CESAM-RD-C  
PUBLIC NOTICE NO.:SAM-2006-1531-MBM

**REQUEST FOR REVISIONS TO PERMIT FOR CONSTRUCTION OF NATURAL GAS  
PIPELINES AND PUMPING STATIONS ASSOCIATED WITH DEVELOPMENT OF A  
NATURAL GAS STORAGE FACILITY IN SOUTH MOBILE COUNTY NEAR CODEN,  
ALABAMA**

**APPLICANT: MoBay Storage Hub, L.L.C.**  
c/o William E. Workman and Associates  
Post Office Box 745  
Lillian, Alabama 36549

**WORK: MoBay Storage Hub L.L.C. (MoBay) requests a modification to their Department of Army (DOA) permit SAM-2006-1531-MBM. This permit authorizes the construction and operation of the MoBay Storage Hub natural gas storage facility in south Mobile County, Alabama. The purpose of the project is to develop and access three underground natural gas storage areas located within the Mississippi Sound. MoBay has prepared the final engineering design and construction plans for all onshore facilities and for the first phase of offshore construction. Certain details of the project, both onshore and offshore, differ from those authorized in the referenced permit. Among other offshore changes, MoBay is requesting DOA authorization to make a second crossing of the Gulf Intracoastal Waterway (GIWW) at MP 7T 0.5

CLIENT: MOBAY STORAGE HUB LLC  
 GIWW CROSSING LAYOUT  
 8" DISTRIBUTION PIPELINE BUNDLE  
 FROM NDJ PLATFORM TO TRIPPOD 7 @ M.P. 17.05  
 BLOCKS 71, 72 & 73  
 MISSISSIPPI SOUND

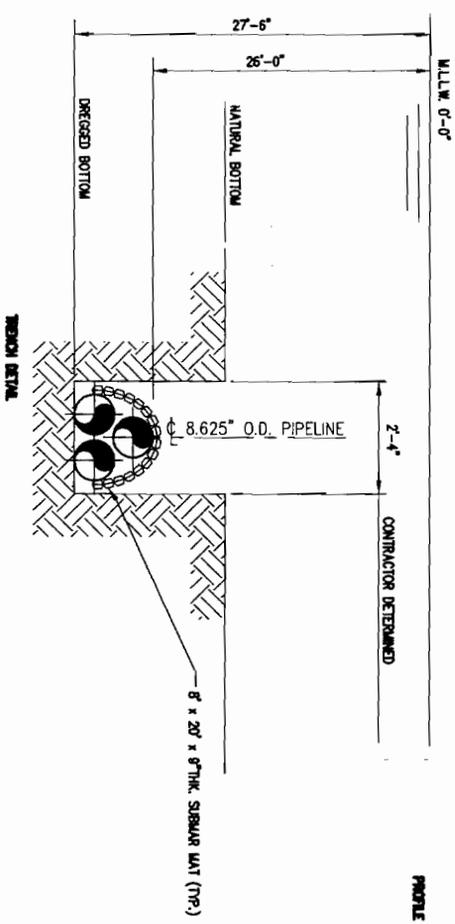
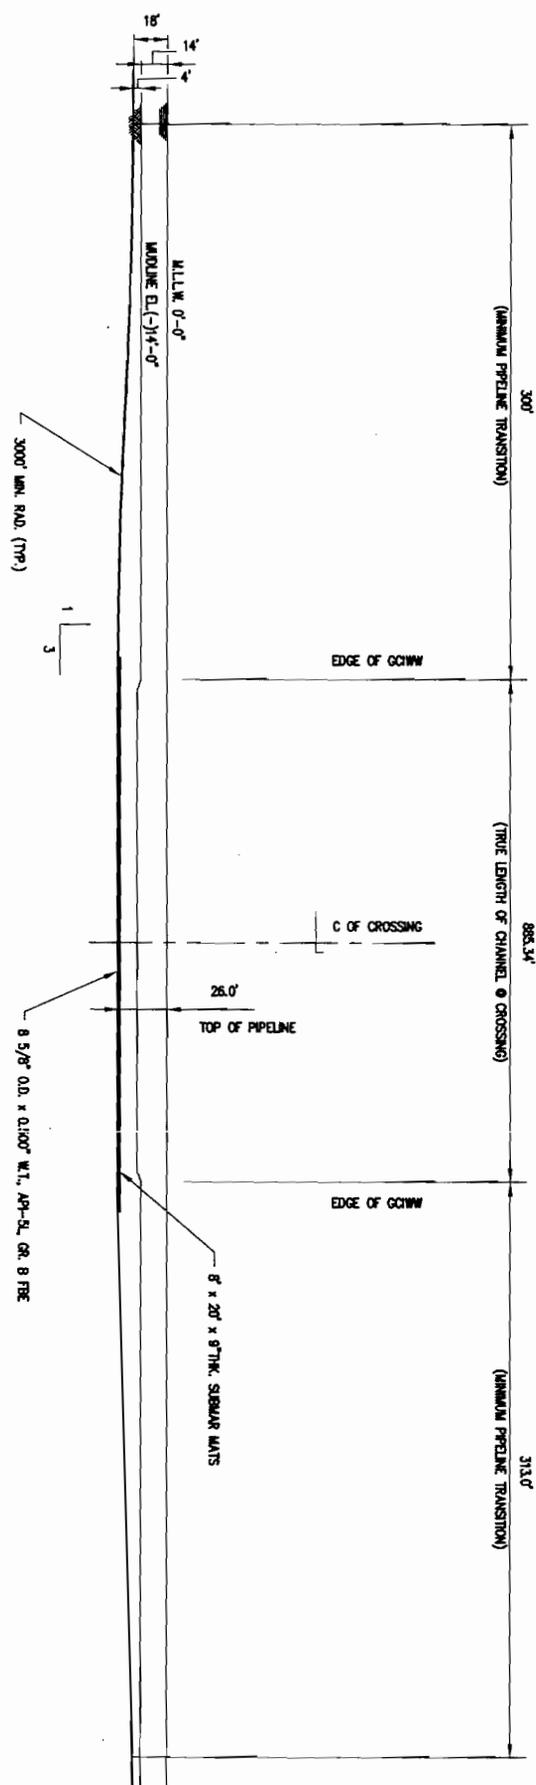
**Similar to the previously authorized crossing requirements, MoBay proposes to bury the three, bundled 8-inch-diameter pipelines to a depth of -26 feet Mean Low Low Water (top of pipe) across the project width of the GIWW and install protective articulating concrete mats over the pipeline spanning the width of the navigation channel.**

NO.	DATE	REVISION	BY	APPROVED
1	10/17/07	REVISED SOUTHEAST MAT COORDS, RE-ISSUED TO COE	ITD	LAB
SCALE:	NOTE	ENCLOSURE	DATE:	1-29-07
DRAWN BY:	ITD	ENCL. NO.	CLIENT APPROVAL	
ITEM 7A	DRAWING NUMBER

BAYDU CODEN VALVE STATION LAYOUT	
FIGURE:	1.232-1
SCALE:	N.T.S.
DRWN/CHK:	HTT/JL
DATE:	6/06
REV:	1

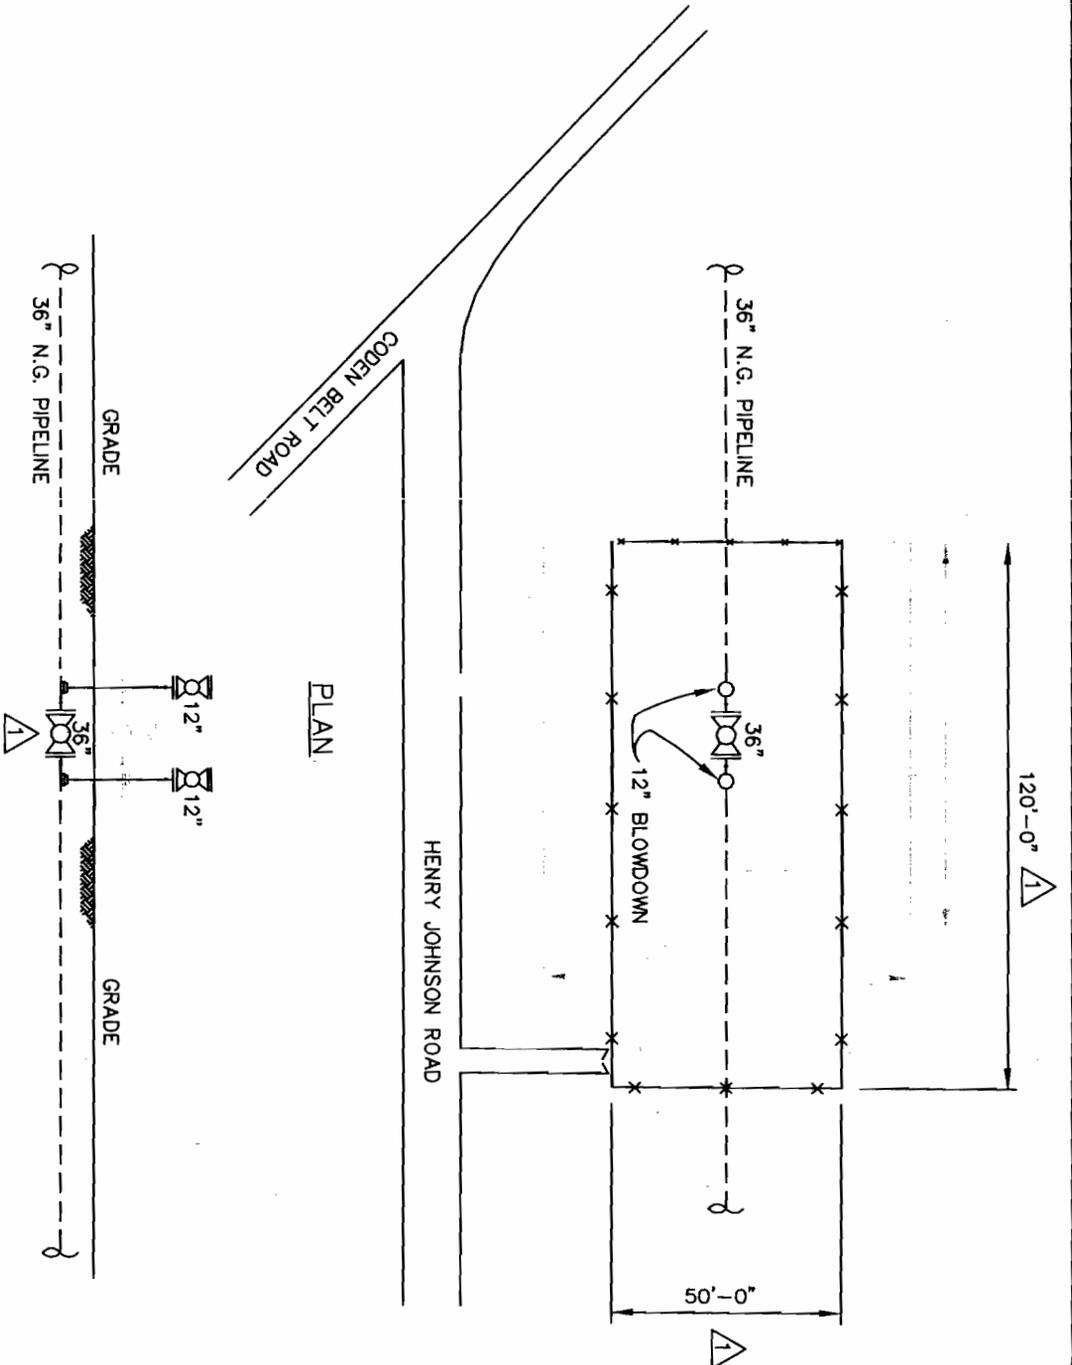
**With the completion of the final engineering designs, the permanent wetland impacts associated with the above ground facilities has changed. The wetland impacts associated with construction and operation of above-ground facilities has decreased in forested wetlands by 0.1 acre for the mainline valve station and 0.6 acre for the meter station. The wetland impacts have increased in the prior-converted wet pasture by 4.2 acres for the MoBay compressor station. The applicant proposes to mitigate for the additional wetland impacts by purchasing credits from an approved wetland mitigation bank.**

—	LEGEND
—	ORIGINAL PERMIT
—	REISSUE CHANGE
